WRU7 - Replacing Tailpipe Covers (Workshop Campaign)

Model Line: **911 (992)**

Concerns: **Tailpipe trim**

Installation position of tailpipe cover

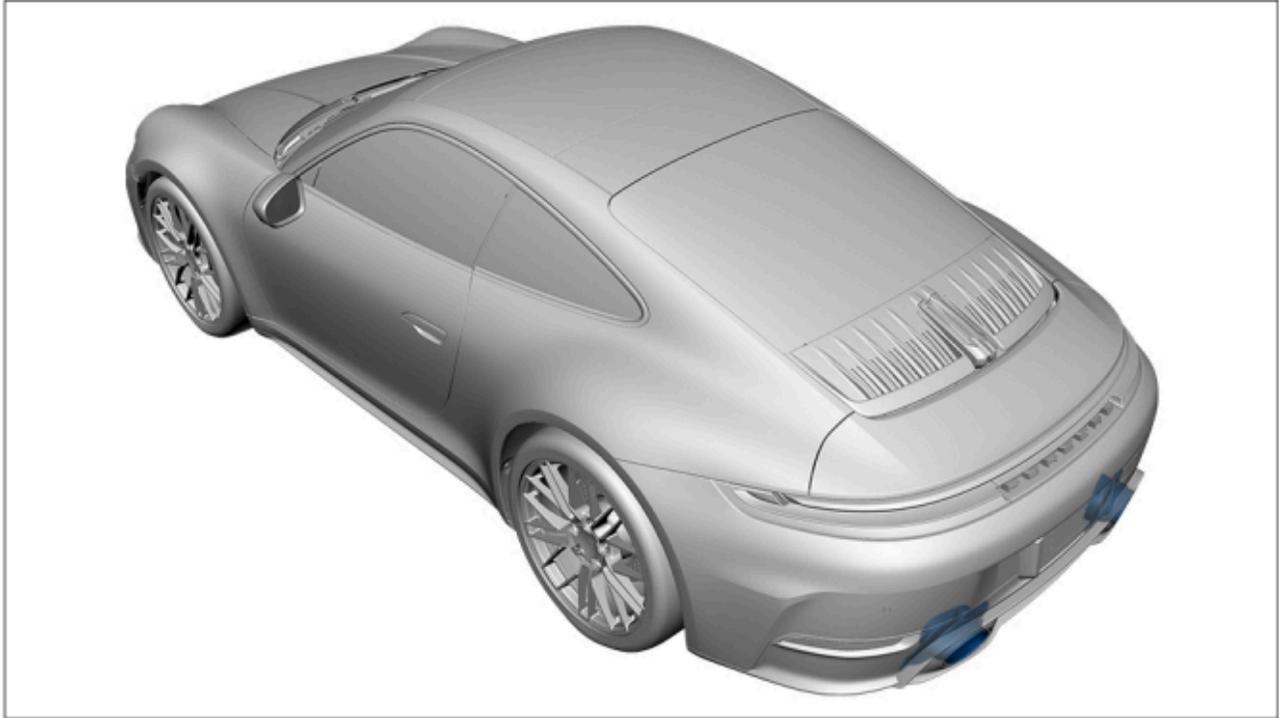
Cause: **During ongoing quality analyses, it was determined that Exclusive tailpipe covers that do not meet the required specifications were installed on the affected vehicles.**
 The long-term quality of the rear apron air intake frame cannot be permanently guaranteed over the service life of the vehicle and under high thermal loads, for example during longer high-speed rides. Customers might consider this as a visual detriment.

Action: Replace Exclusive tailpipe covers with sports tailpipe covers.

- Work Procedure: 1 Replace **temporary** Exclusive tailpipe covers with sports tailpipe covers.
For work procedure, see: ⇒ *Workshop Manual '263519 Removing and installing tailpipe trim'*
- 2 Enter the campaign in the Warranty and Maintenance Logbook.
